## County of Fairfax, Virginia

**STAFF REPORT ADDENDUM**  
**APPLICATION RZ 2015-HM-010**  
**HUNTER MILL DISTRICT**

# GENERALIZED DEVELOPMENT PLAN (GDP) FOR **WARNER SUBDIVISION** HUNTER MILL DISTRICT FAIRFAX COUNTY, VIRGINIA

## REASON FOR THE ADDENDUM

Figure 1- Applicants' Revised GDP

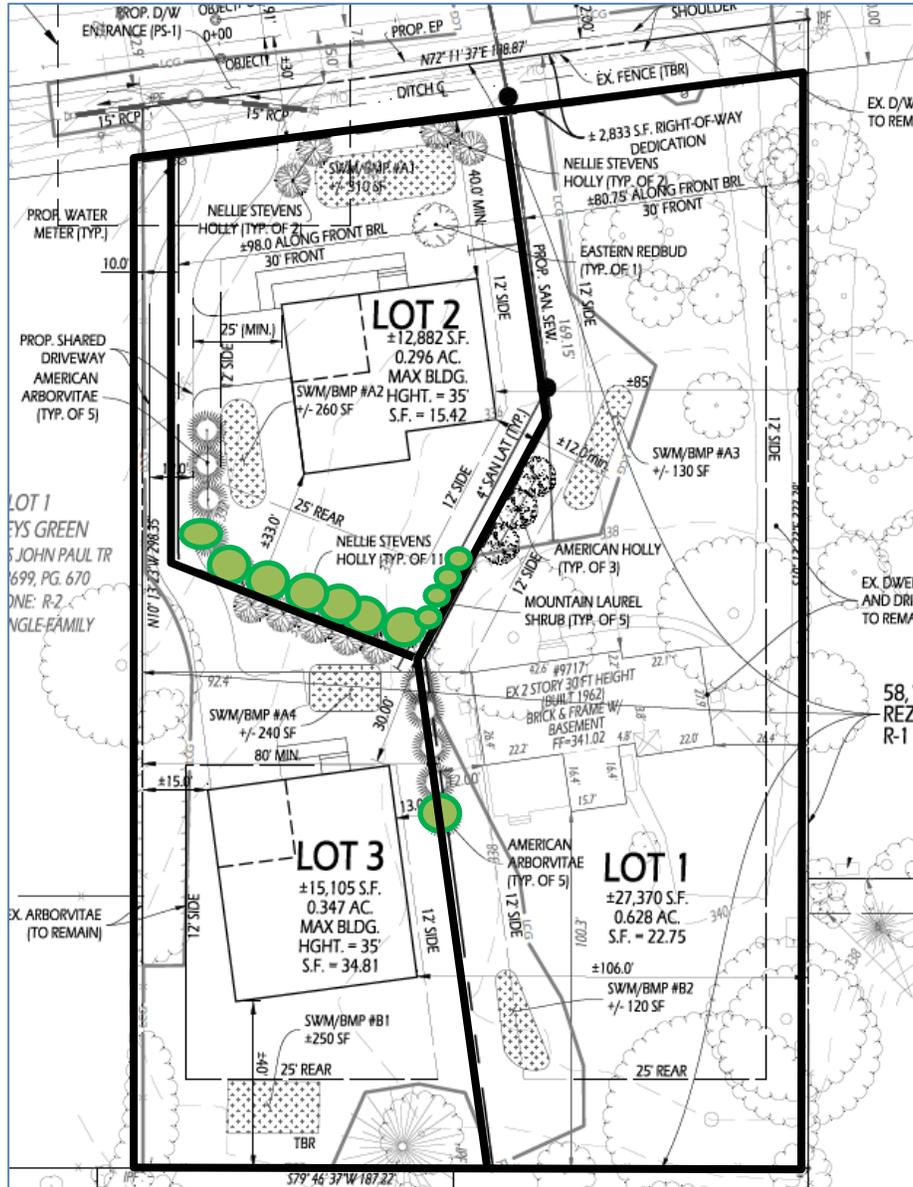
Since the publication of the staff report dated January 13, 2016, it came to staff's attention that one of the proposed lots did not meet the shape factor required for the Zoning Ordinance. The applicants have updated the General Development Plan (GDP) to demonstrate that all lots meet the shape factor requirements of the Zoning Ordinance<sup>1</sup> and have added additional evergreen landscaping for screening between the proposed lots (see Figure 1). The applicants have decreased the area of Lot 2 by about 1,000 square feet and have increased the area of Lot 3 by 1,000 square feet.

The applicants have added additional screening between Lots 1, 2 and 3. Evergreen landscaping has been added along the southern property lines of Lot 2 and along the northern and eastern property lines of Lot 3 (as shown in Figure 1). Staff believes the additional evergreen landscaping increases the visual buffer and provides more privacy between all of the proposed lots. In addition, previously proposed proffers have been carried over to this addendum including tree preservation, construction monitoring, root pruning, and tree protection that are typically recommended by the Department of Public Works and Environmental Service's (DPWES) Urban Forest Management Division (UFMD).

The applicants revised their GDP to reflect the additional landscaping to increase screening between the properties and modified the boundary lines to ensure that all lots met the shape factor requirements in the Zoning Ordinance. The overall layout and location of the buildings was slightly altered to meet the aforementioned shape factor. The remainder of the RZ application remains unchanged.
